Z-53
(2012)

SURVEY OF PROPERTY
FOR
DAVID ARNOLD
LAND LOT 189, * 18TH DISTRICT * 2ND SECTION
COBB COUNTY, GEORGIA
DATE: NOVEMBER 5, 2009
SCALE: 1" = 50'

PETITION NO: Z-53

PROPOSED USE: Church Activities
and LED Sign

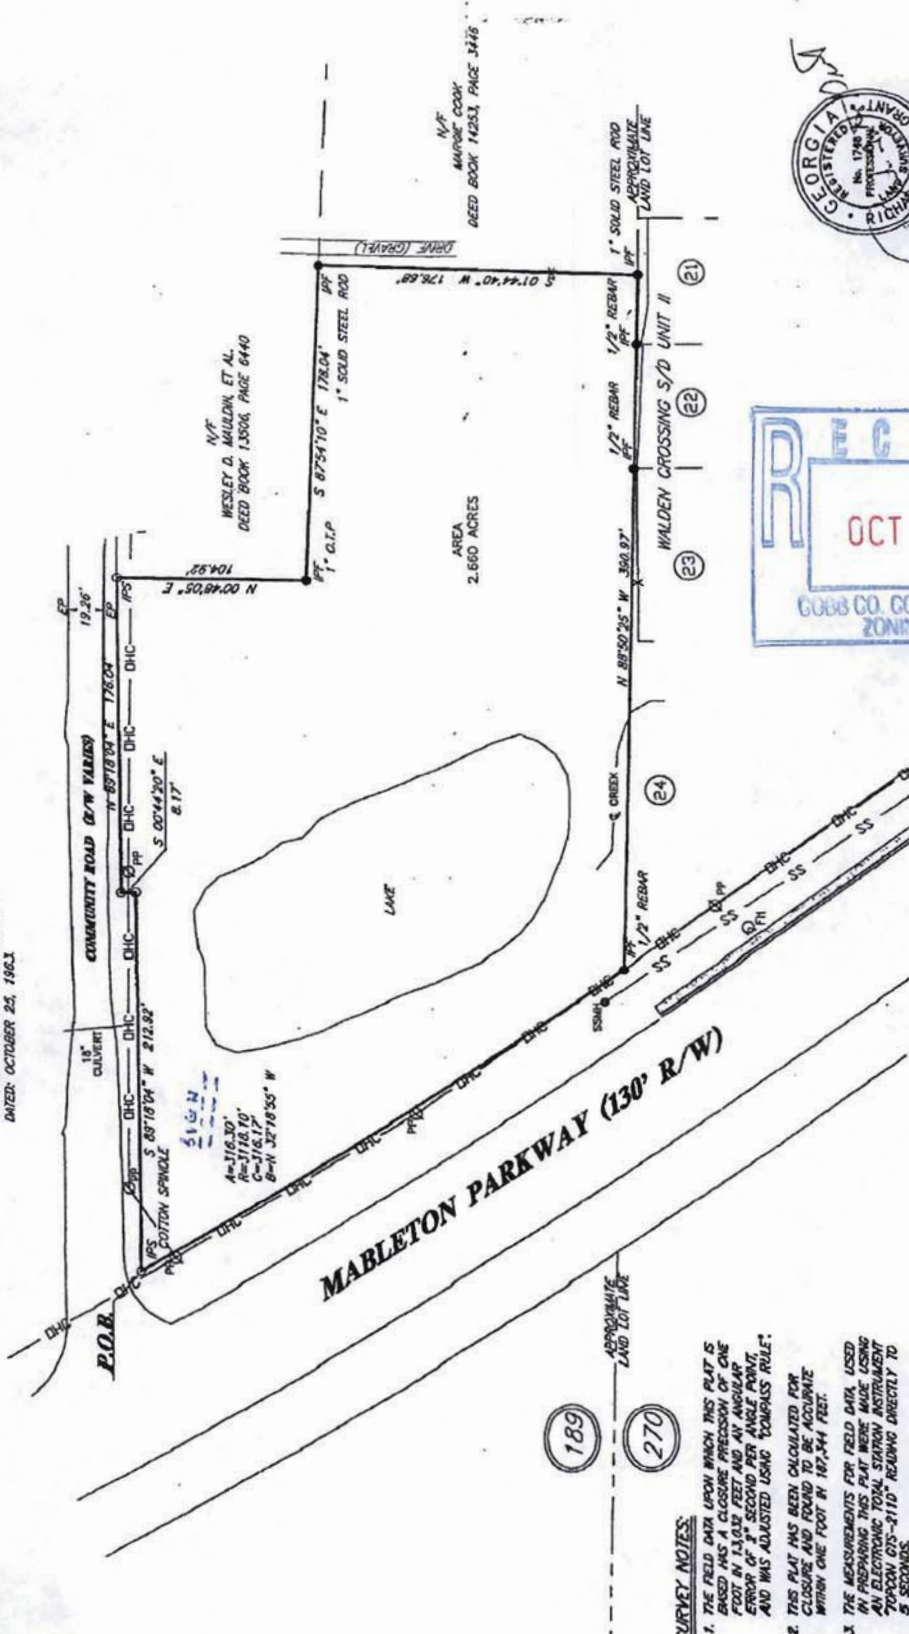
- ☐ No Stormwater controls shown _____
- ☐ Copy of survey is not current – Additional comments may be forthcoming when current site conditions are exposed.
- ☒ No site improvements showing on exhibit.

1. This site is currently undeveloped, but has a small existing pond located along its frontage with Mableton Parkway. The pond appears to be spring-fed since it has a bypass channel around most of its perimeter. The pond area is in need of maintenance and cleanup. The bypass channel through the site has been filled with brush and tree clippings which must be removed. The pond dam does not appear to have adequate spillway capacity since a head cut has eroded approximately 1/4 of the way through the dam. These maintenance issues must be addressed as soon as possible.
2. If any improvements are proposed in this parcel, then the dam must be brought up to Cobb County Development Standards.

Z-53 (2012)
Sign Rendering

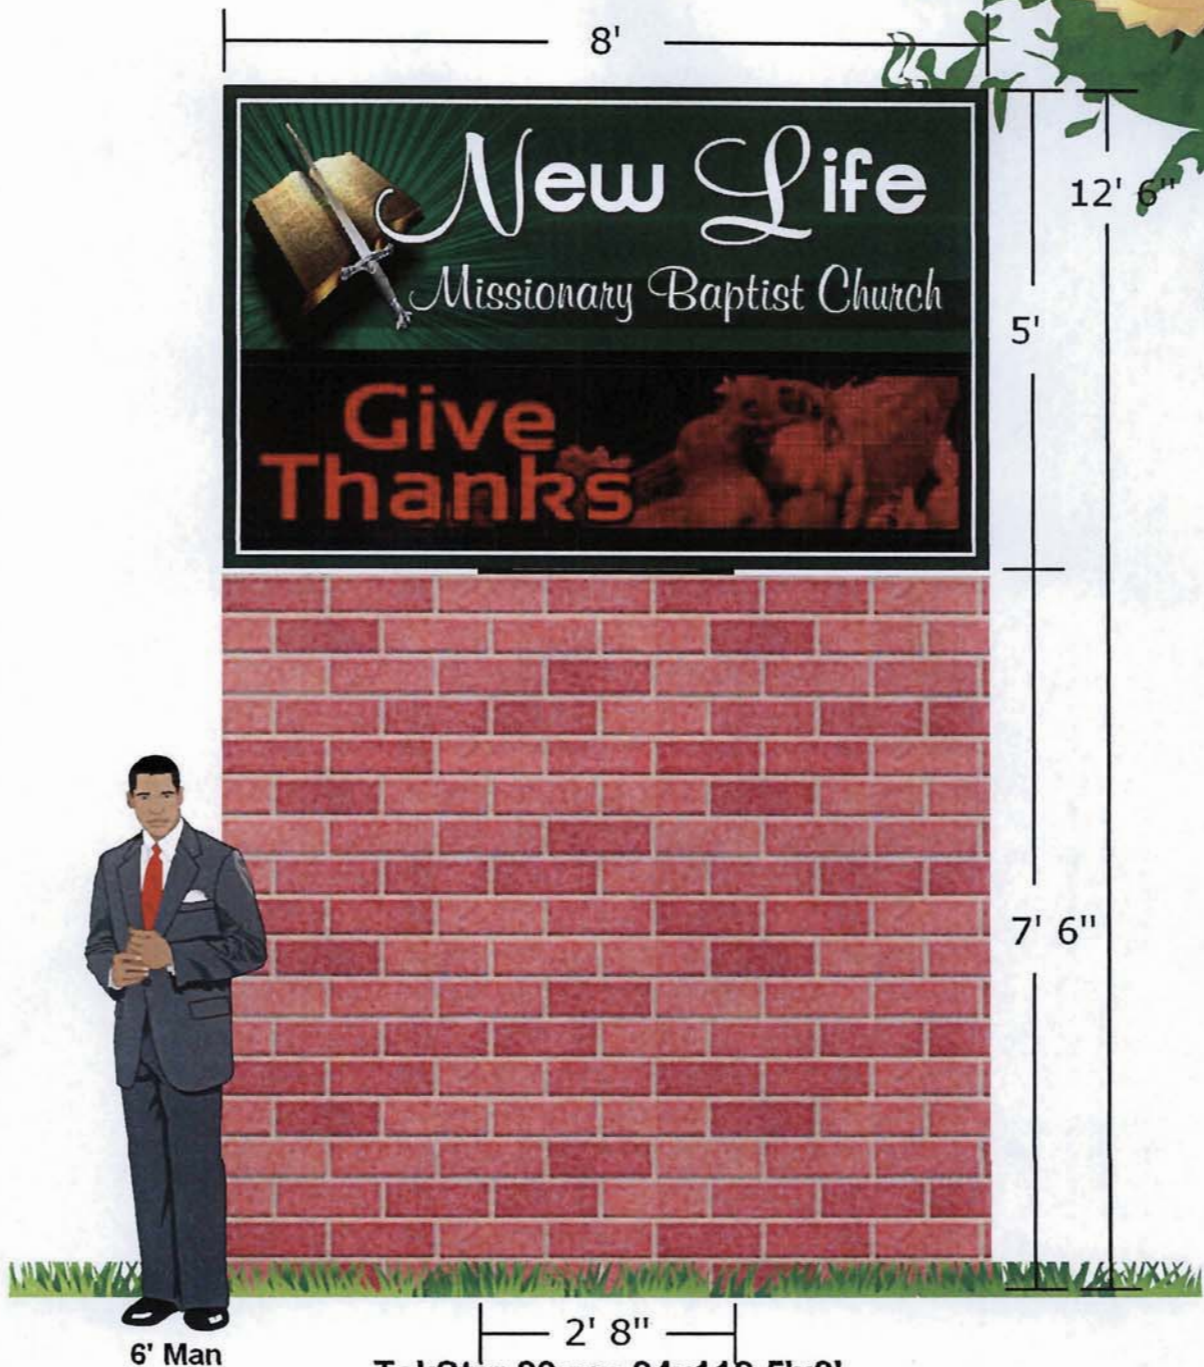
Applicant is requesting the Office and Institutional (O&I) zoning category in order to erect a 100 square-foot monument sign for the church. The rendering of the proposed sign is attached to this analysis and indicates a sign area of 40 square feet on the overall monument. The O&I zoning category is needed in order to erect a sign this size, as well as meeting the requirement that this type of sign must be in a commercial zoning category. The actual church building is located a little further down Community Road. The subject property will also be used for church activities such as games, cookouts, outside spring and fall services, etc. The subject property was rezoned from GC and R-20 to RA-5 to a site plan as part of Z-175 of 2005 (minutes attached).

- Only the proposed uses of a sign and outdoor recreational/seasonal service locations for the church;
- Sign rendering attached to this analysis;
- Maintain the required 50-foot landscaped or natural screening buffer abutting residentially zoned properties;
- District Commissioner to approve minor changes;
- Water and Sewer comments and recommendations;
- Stormwater Management comments and recommendations;
- DOT comments and recommendations; and
- Owner/developer to enter into a Development Agreement pursuant to O.C.G.A. §36-71-13 for dedication of system improvements to mitigate traffic concerns.
